Year 3 Monitoring Report

LITTLE SEBASTIAN SITE

NCDMS Project # 100027 (Contract # 7187) | RFP 16-006993 (Issued 9/16/2016)
USACE Action ID: SAW-2017-01507 | DWR Project # 2017-1041

RE: Little Sebastian, Project ID #100027, DMS Contract #7187

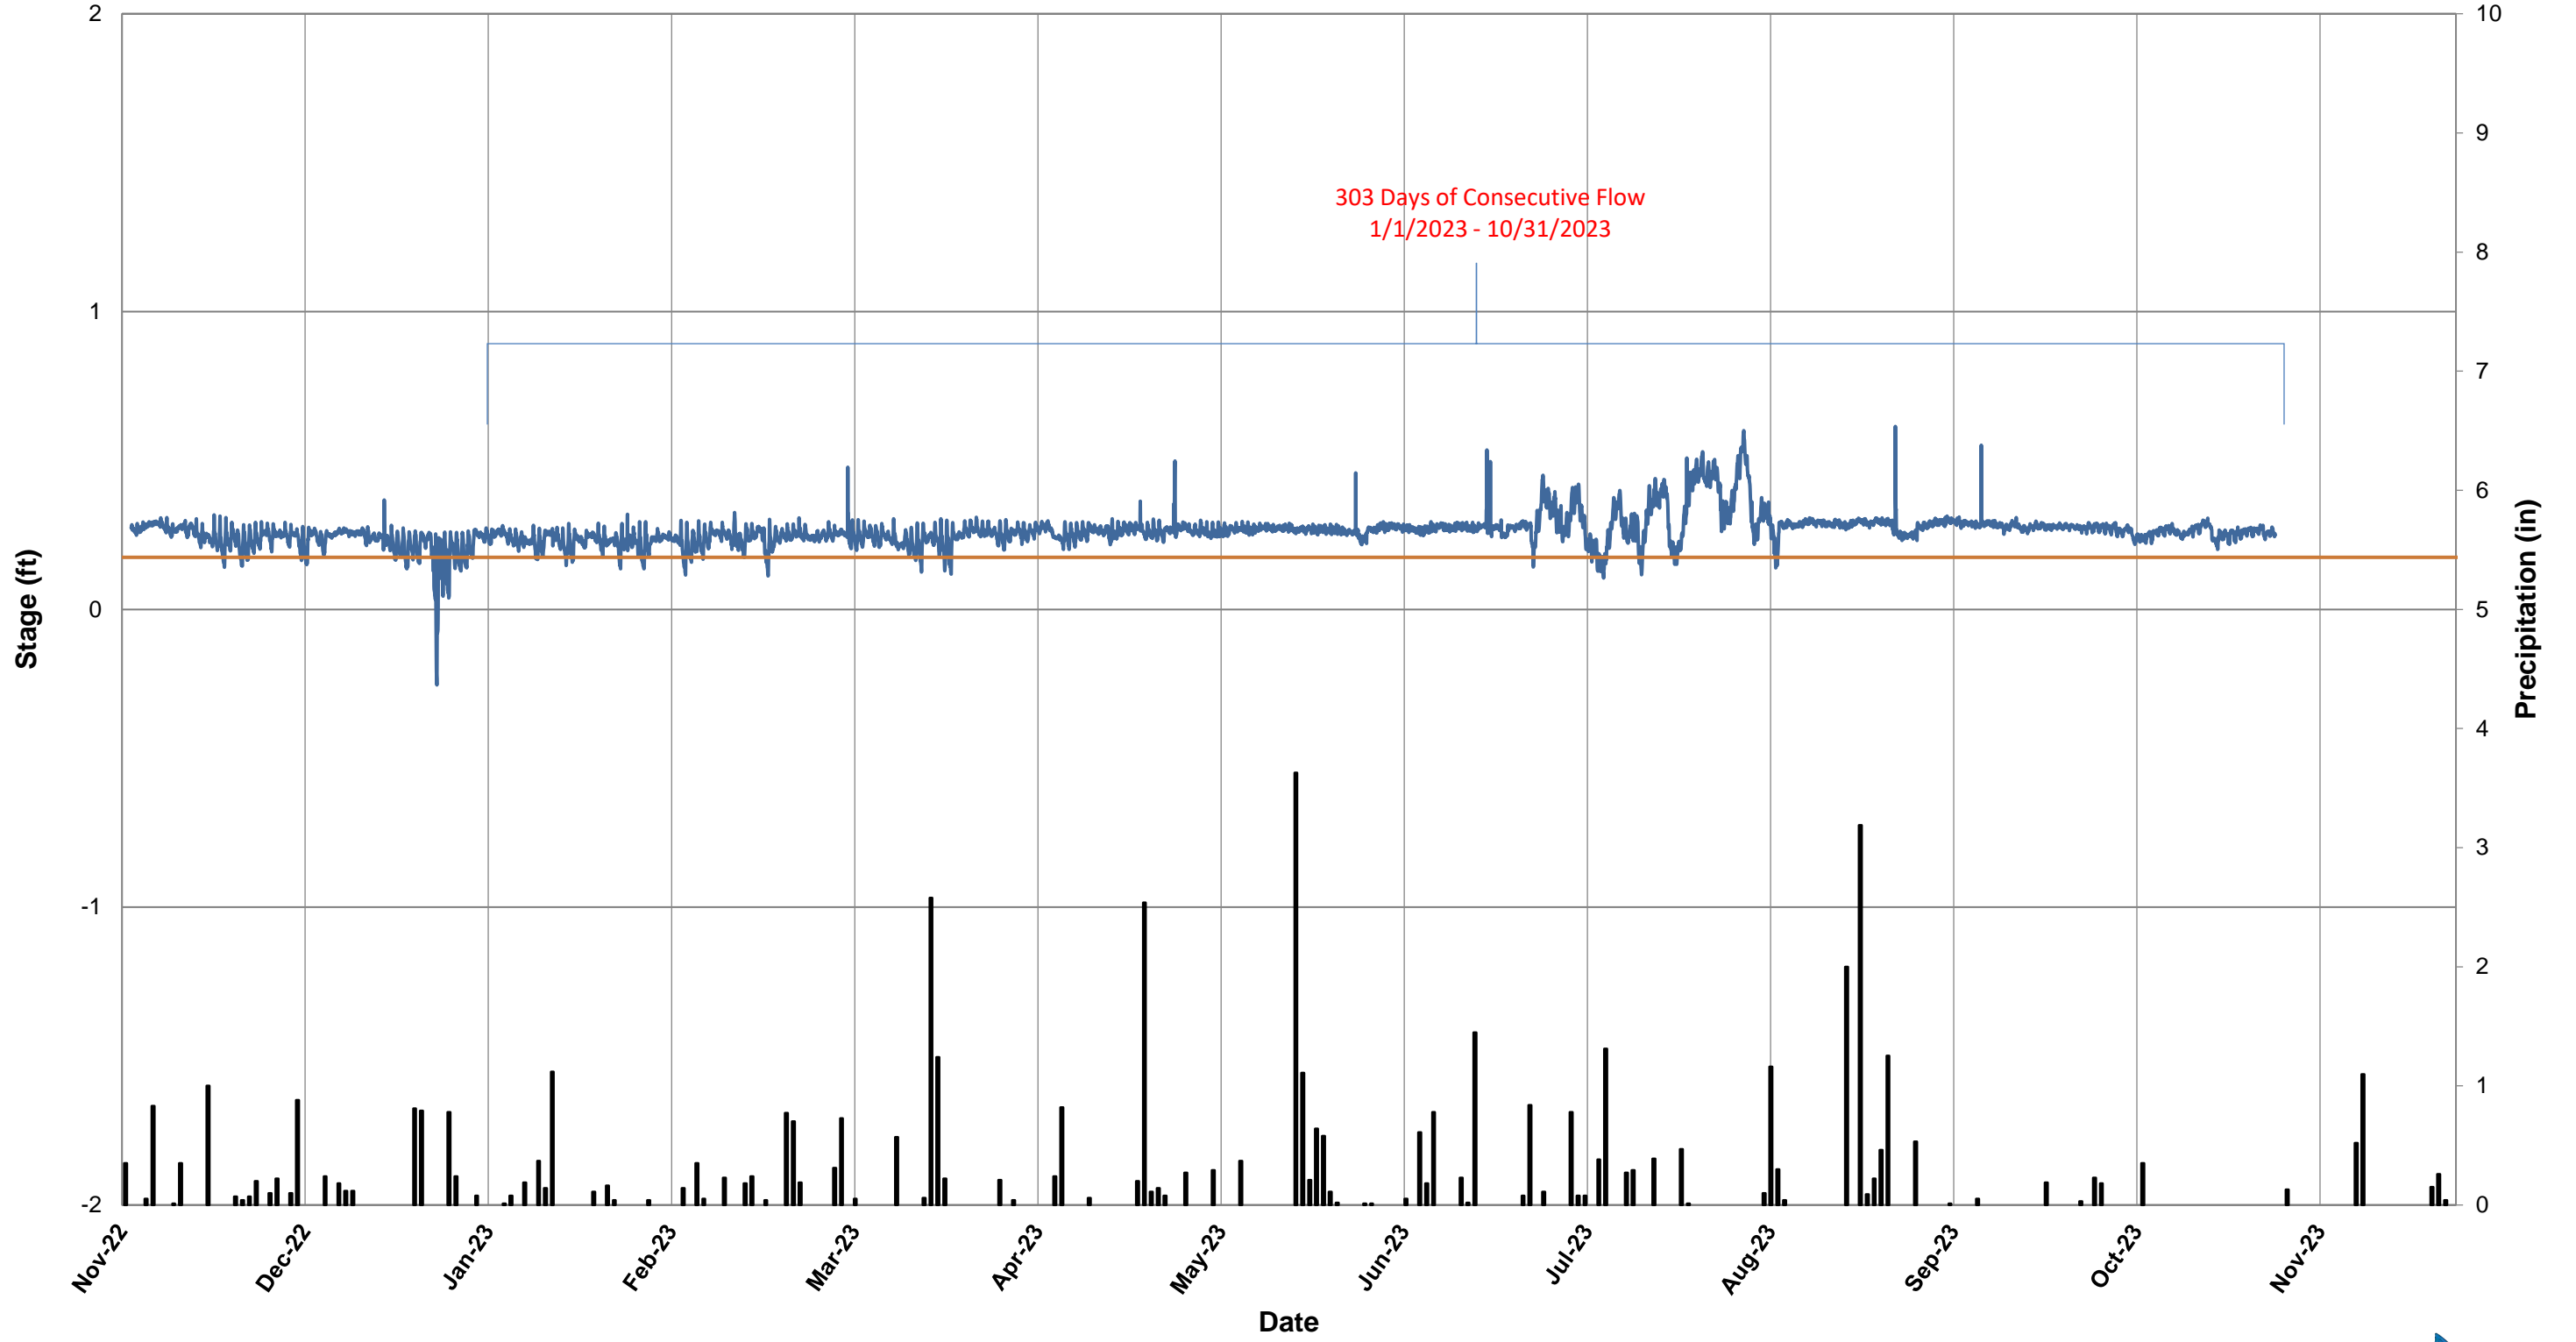
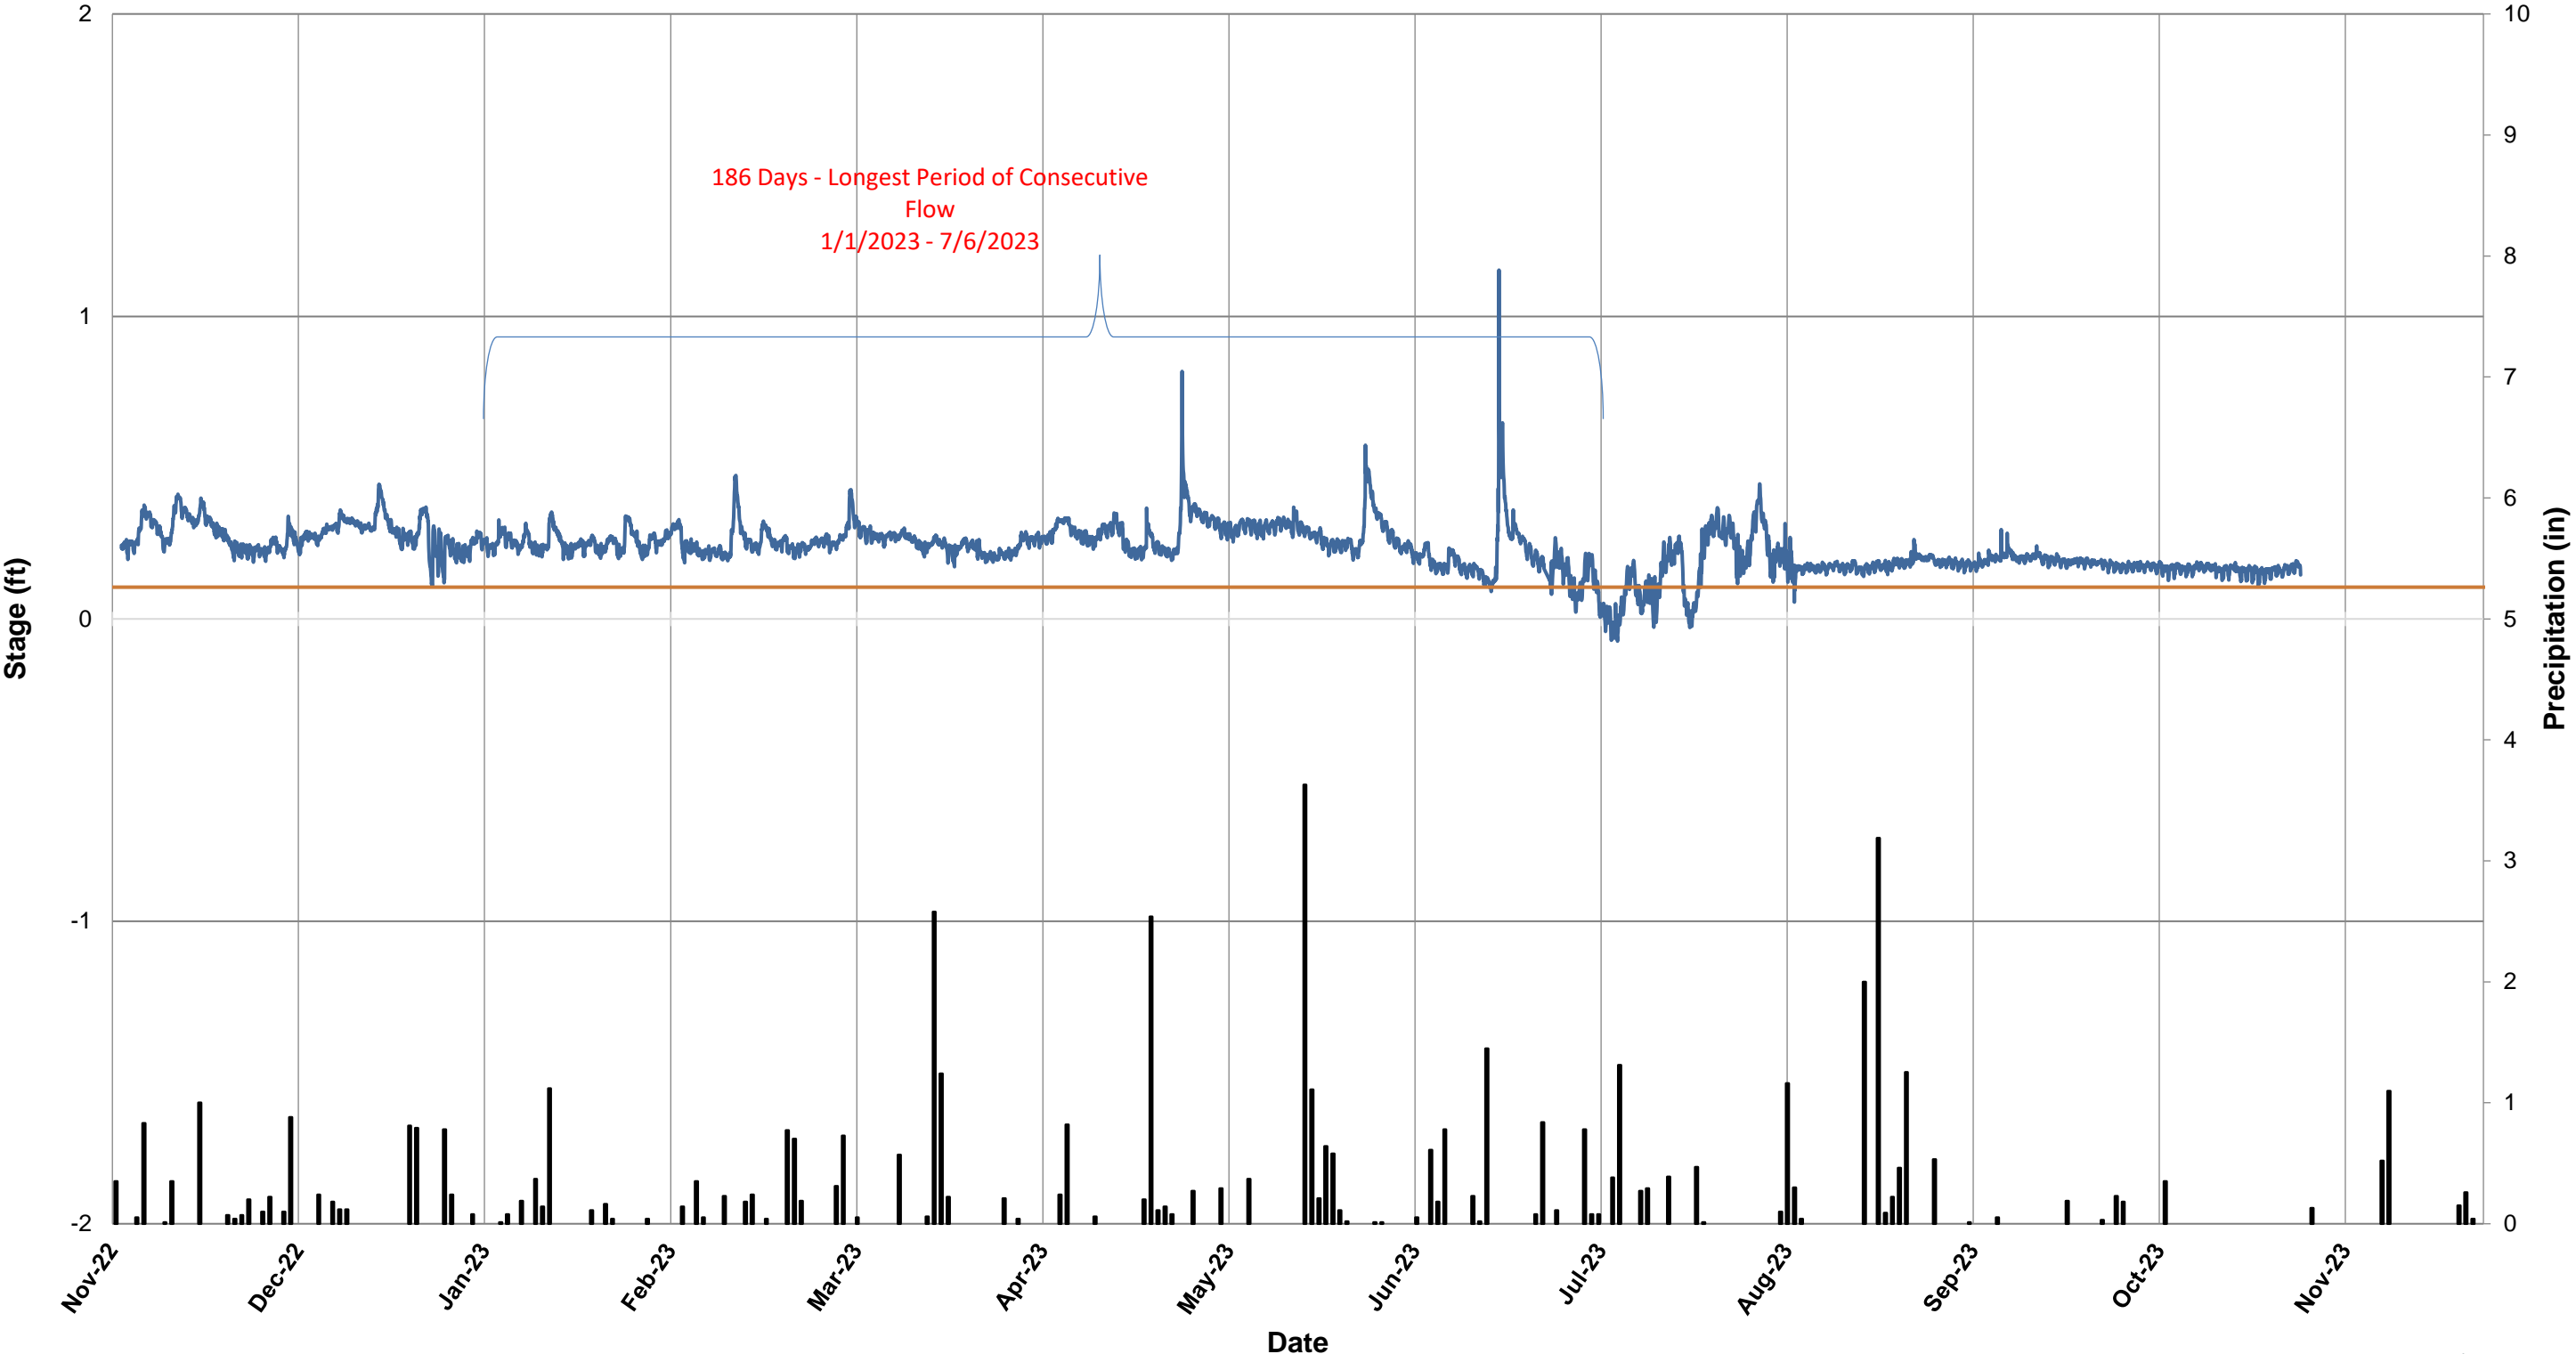
17. MY3 Little Sebastian Flow Gauge Graphs (all): The Longest Period of Consecutive Flow callouts shown have numerous instances where the water line drops below the Downstream

Riffle Elevation Line. Please review and revise the report as necessary. Please explain why consecutive flow data reported includes instances when the waterline drops below the downstream riffle elevation.

All of the flow gauges drop below the downstream riffle elevation during the longest period of consecutive flow; however, the gauge reads 24 times a day and for the instances that where the water level drops below the downstream rifle it is less than 24 hours in a row. The consecutive day count does not stop until there is 24 hours in a row where there is flow less than the downstream rifle. Please reference the flow gauge raw data in the digital files (5. Hydrology Data) to see where the determinations come from.
